ADDENDUM

PLANNING DIVISION REPORT DEPARTMENT OF PLANNING AND COMMUNITY AND ECONOMIC DEVELOPMENT November 3, 2008

RE: LD. # 11614 Zoning Map Amendment I.D. 3382 To Rezone – 5555 High Crossing Boulevard from C2 (General Commercial District) to C3 (Highway Commercial District)

5555 High Crossing Boulevard Rezoning - Revised

Map for proposed access & past review for access on High Crossing Blvd and Nelson Rd.

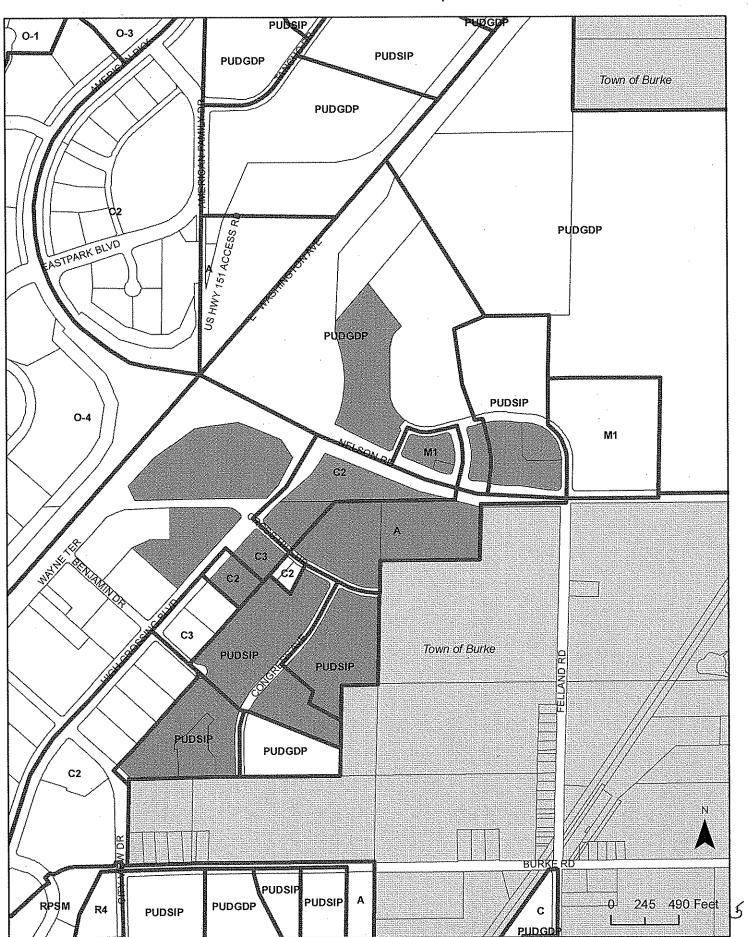
I have reviewed and discussed with my supervisor. We do not have any objections to the right-in/right-out to Nelson Road as shown on the attached site plan.

I do have a question though for the connection to High Crossing Blvd? Is this a public or private connection? what properities will this connection serve?

The High Crossing Blvd Access is okay with the City. It does fall within 1000 ft of interchange. Is the location okay with the WDOT?
